## 35-TYPE CONVERTER SETS — ADJUSTMENTS

*APPARATUS AFFECTED:* 35A, 35B, 35D, 35E, 35F, 35G and 35H Converter Sets.

**SECTION 570-113-401.01**

**1.19 GEAR MECHANISM****(A) INTERMEDIATE SHAFT  
REQUIREMENT**

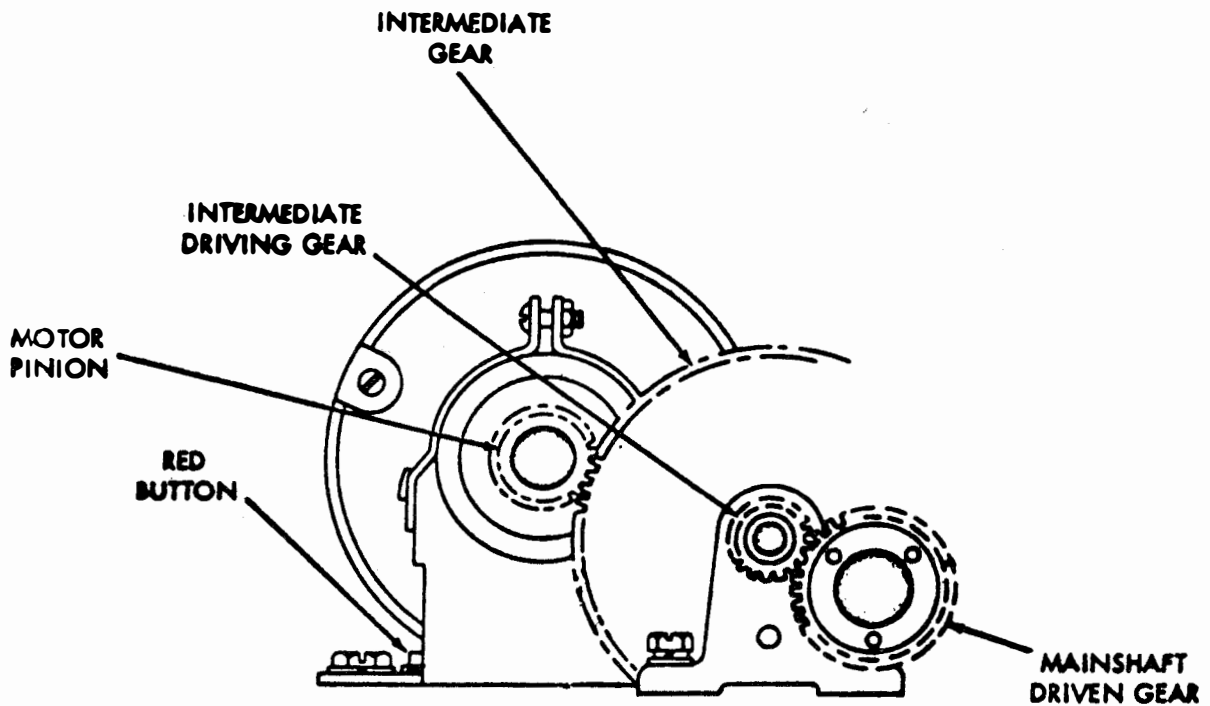
(1A) *Section 570-106-700, Issue 3, Page 30, Paragraph 3.19*

(A) Tape Reader Gear Backlash

The location of subparagraph (A) on page 30 has been changed and will read as subparagraph (B) Tape Reader Gear Backlash.

The requirement (A) Tape Reader Gear Backlash has been changed:

From: "Only a perceptible amount of backlash between main shaft driven gear and intermediate driving gear."

To: "Only a perceptible amount of backlash between main shaft driven gear and intermediate driving gear at point where backlash is least."

(B) Intermediate Shaft

The location of subparagraph (B) on page 30 has been changed and will read as subparagraph (A) Intermediate Shaft.

The requirement of Min. 0.015 inch—Max. 0.020 inch has been deleted.

"To Adjust" of new (A) Intermediate Shaft, has been changed:

From: To Adjust.

Position the intermediate shaft assembly to the forward plate loosened.

To: To Adjust.

Loosen the two intermediate gear bracket screws and position intermediate gear bracket.

The note to subparagraph (B) Intermediate Shaft, has been changed:

From: Note: Intermediate shaft adjustment required only on miniaturized base.

To: Note: In some cases, it may be necessary to loosen the motor mounting screws and position the motor to meet the requirements.

The new requirements are shown on attached sheet which should be used as temporary addendum to page 30, Section 570-106-700.

ONLY A PERCEPTIBLE AMOUNT OF BACKLASH BETWEEN THE MOTOR PINION AND INTERMEDIATE GEAR AT POINT WHERE BACKLASH IS LEAST.

**TO ADJUST**

LOOSEN THE TWO INTERMEDIATE GEAR BRACKET SCREWS AND POSITION INTERMEDIATE GEAR BRACKET.

**NOTE:** IN SOME CASES IT MAY BE NECESSARY TO LOOSEN THE MOTOR MOUNTING SCREWS AND POSITION THE MOTOR TO MEET THE REQUIREMENT.

**(B) TAPE READER GEAR BACKLASH****REQUIREMENT**

ONLY A PERCEPTIBLE AMOUNT OF BACKLASH BETWEEN MAINSHAFT DRIVEN GEAR AND INTERMEDIATE DRIVING GEAR AT POINT WHERE BACKLASH IS LEAST.

**TO ADJUST**

LOOSEN THREE TAPE READER MOUNTING SCREWS AND POSITION TAPE READER.
